Access Compliance Report

Public Rights-of-Way

(Curb Ramps)

Intersection ID: 9059	Main Street: GLENWOOD_DR	Cross Street: S_I85_EXIT_35_RA	Location: S
ADA ID: C89CADC8E56A	Ramp Type: PerpDiag	Initial Pass/Fail: Fail	Overall Compliance: No
		Severity Score: 30

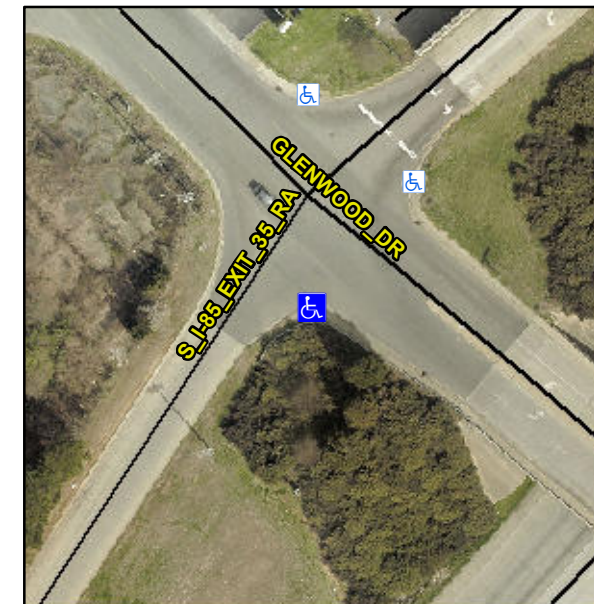
Not Found, R304.5.1, R304.2.2

Compliance	Description	Data	Compliance	Description	Data
N/A	Ramp Length (in)	59.0	No	Ramp Slope (%)	10.4
No	Ramp Width (in)	35.0	Yes	Ramp XSlope (%)	0.6
N/A	Flare Type LT	N/A	N/A	Flare Type RT	N/A
N/A	Flare Slope LT (%)	N/A	N/A	Flare Slope RT (%)	N/A
N/A	Flare Traversable LT?	N/A	N/A	Flare Traversable RT?	N/A
N/A	Landing Length (in)	N/A	N/A	DWS Provided?	N/A
N/A	Landing Width (in)	N/A	N/A	DWS Contrast?	N/A
N/A	Landing Slope (%)	N/A	N/A	DWS Length (in)	N/A
N/A	Landing X Slope (%)	N/A	N/A	DWS Full Width?	N/A
N/A	Landing Curb? (Y/N)	N/A	N/A	DWS Offset (in)	N/A
N/A	Shared Landing?	N/A			
N/A	Gutter Ponding?	N/A	N/A	Gutter Slope (%)	N/A
N/A	Gutter Lip Ht (in)	N/A	N/A	Gutter X Slope (%)	N/A
N/A	Painted X Walk1?	No	N/A	Painted X Walk2?	No
	X Walk 1 Direction	To NE		X Walk 2 Direction	To NW
N/A	X Walk 1 Width (in)	N/A	N/A	X Walk 2 Width (in)	N/A
	X Walk 1 Slope (%)	1.2		X Walk 2 Slope (%)	1.8
	X Walk 1 X Slope (%)	2.4		X Walk 2 X Slope (%)	0.9

Remove & Replace Curb Ramp With Two New Directional Ramps or Equivalent.
